**DFCM Addendum #2**

**Reference:** USDB Storefront Window Replacement Phase 1  
 DFCM Project #25262230  
 U3P Event #CS25034

**Date** 2/6/2025  
**Project Name** USDB Storefront Window Replacement Phase 1  
**Project Number** DFCM Project #25262230

**Re: Bid Questions**

**1 LEVEL 1 FLOOR PLAN**  
A101 1/32" = 1'-0"

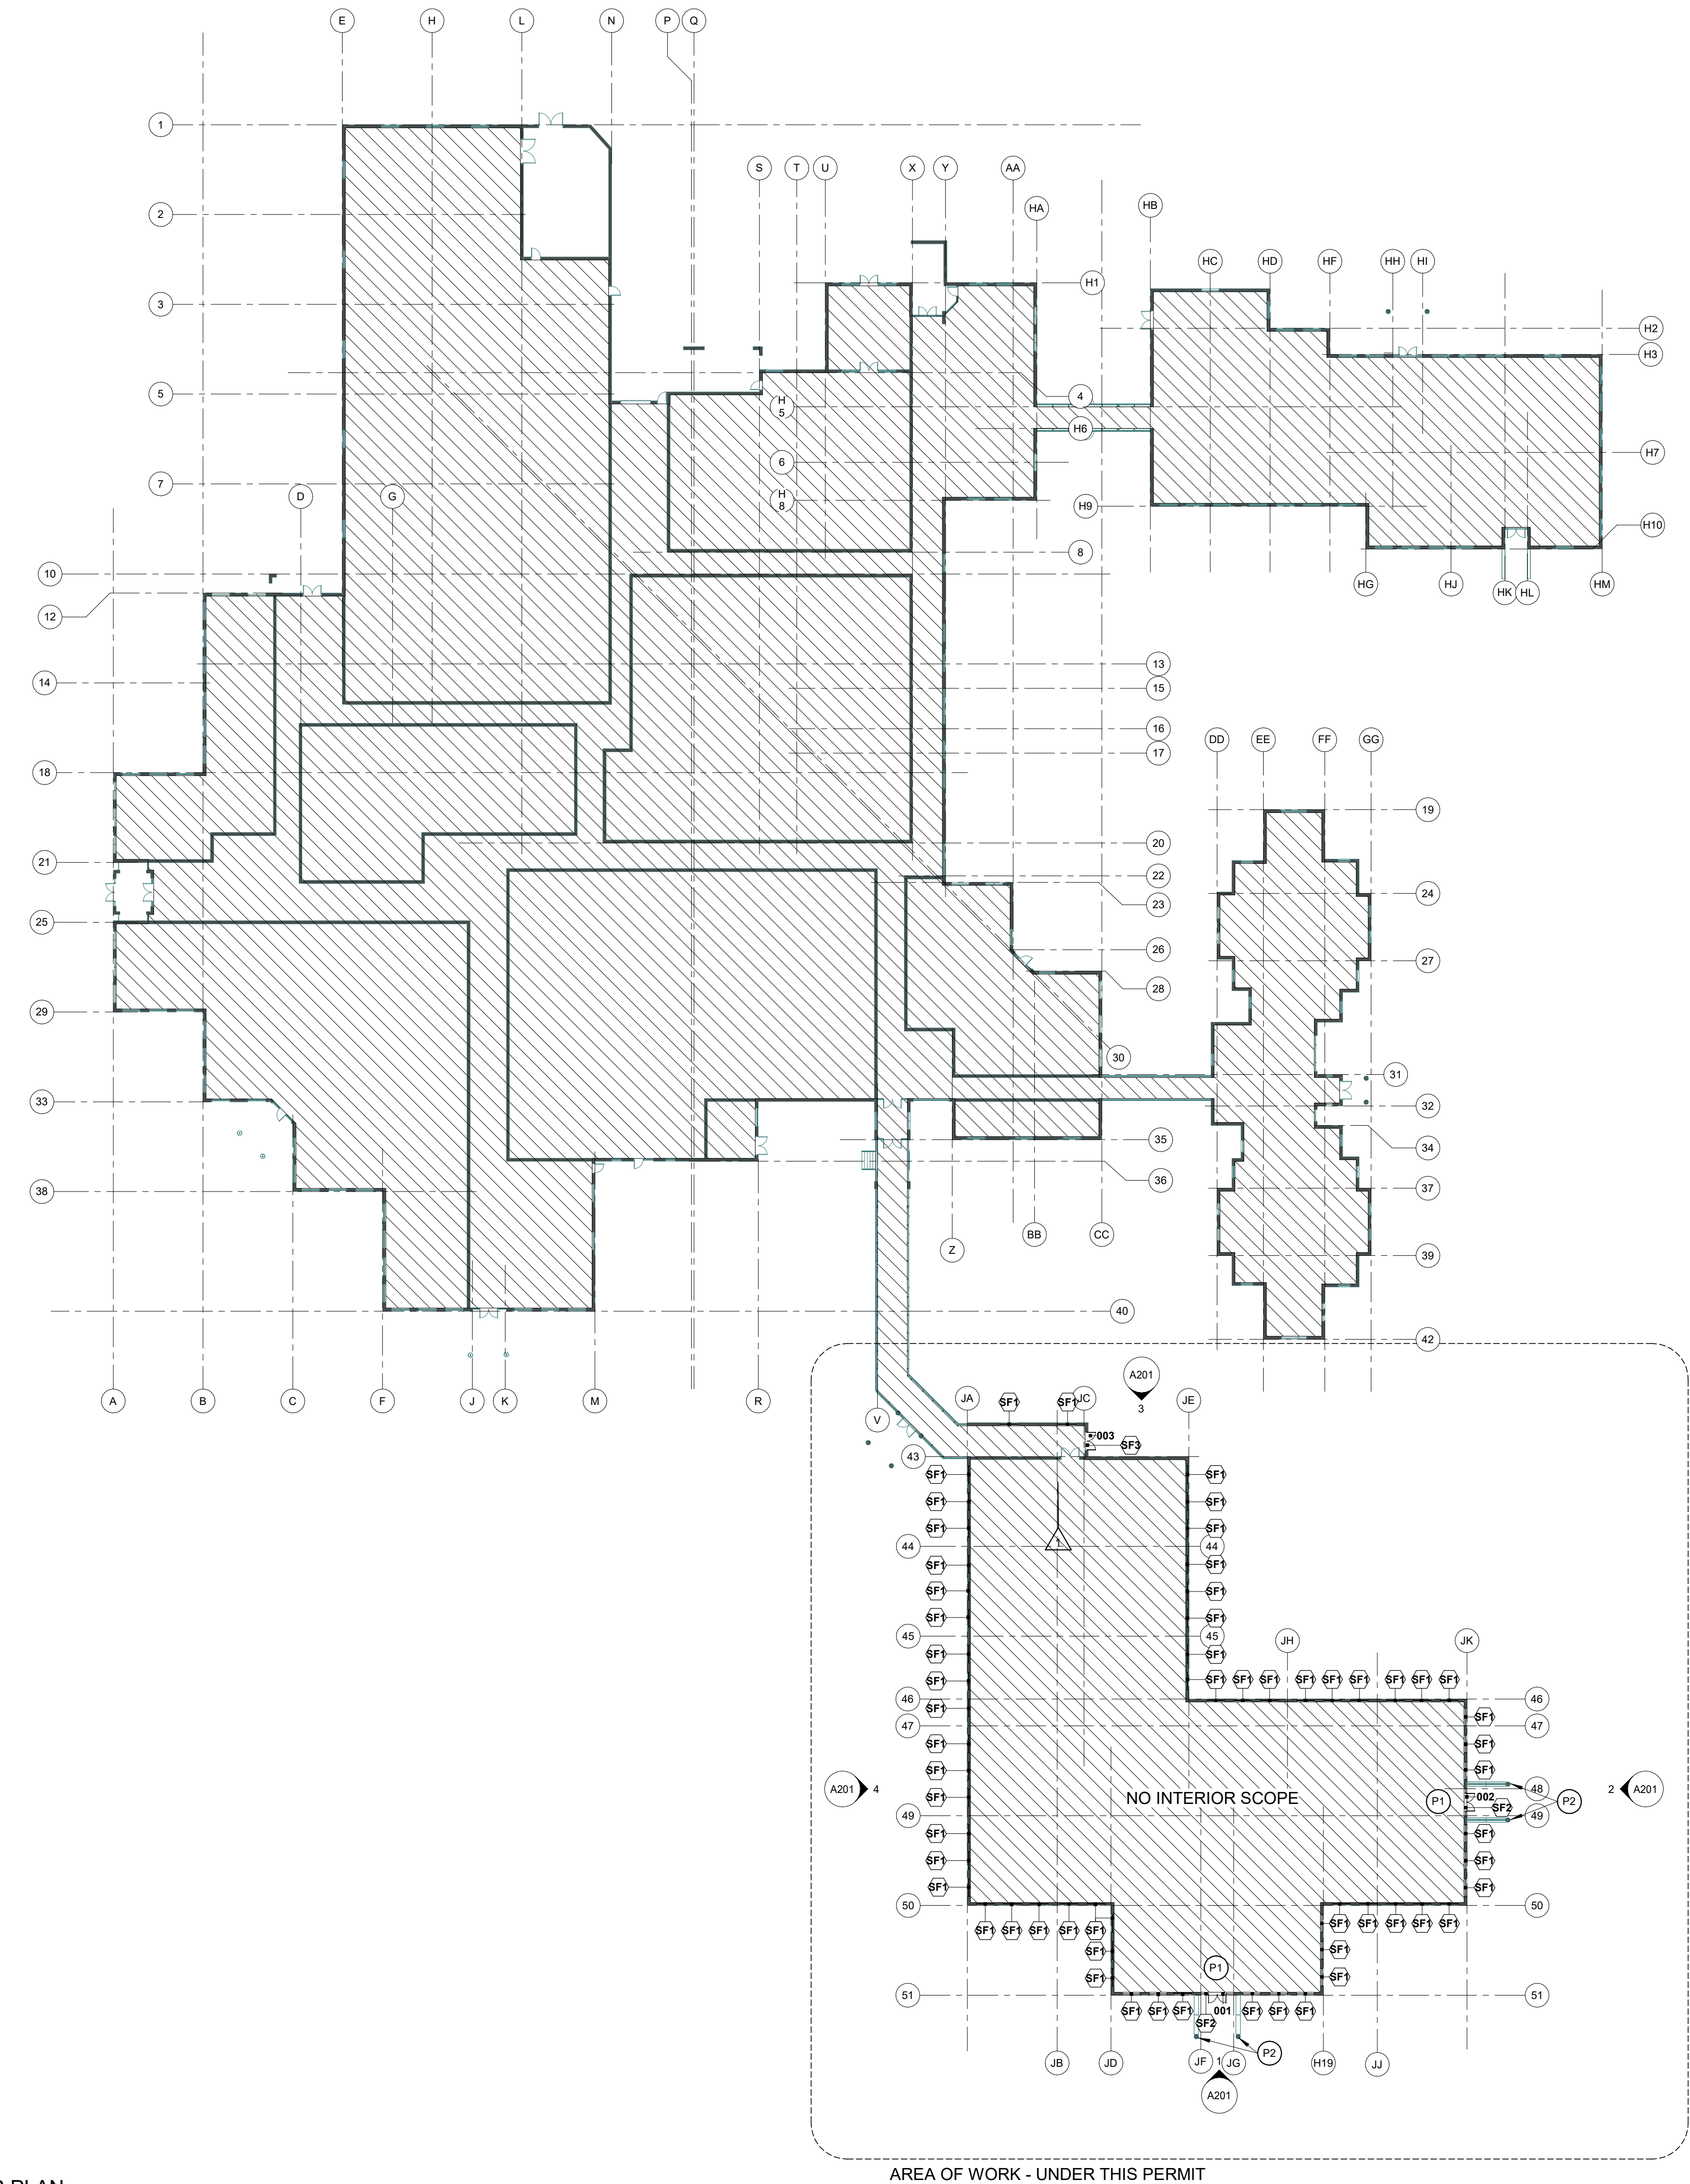
***MSR Design: Contractor shall patch and repair around new windows, doors, and interiors sills as required per detail 5/A651. "ALLOWANCE" has been removed from the specification table of contents and General Notes to clarify this.***

- (P1) ADD ALTERNATE: REPLACE INTERIOR VESTIBULE DOOR TO PROVIDE 10" BOTTOM RAIL
- (P2) GLAZING TO REMAIN: REPLACE CAP
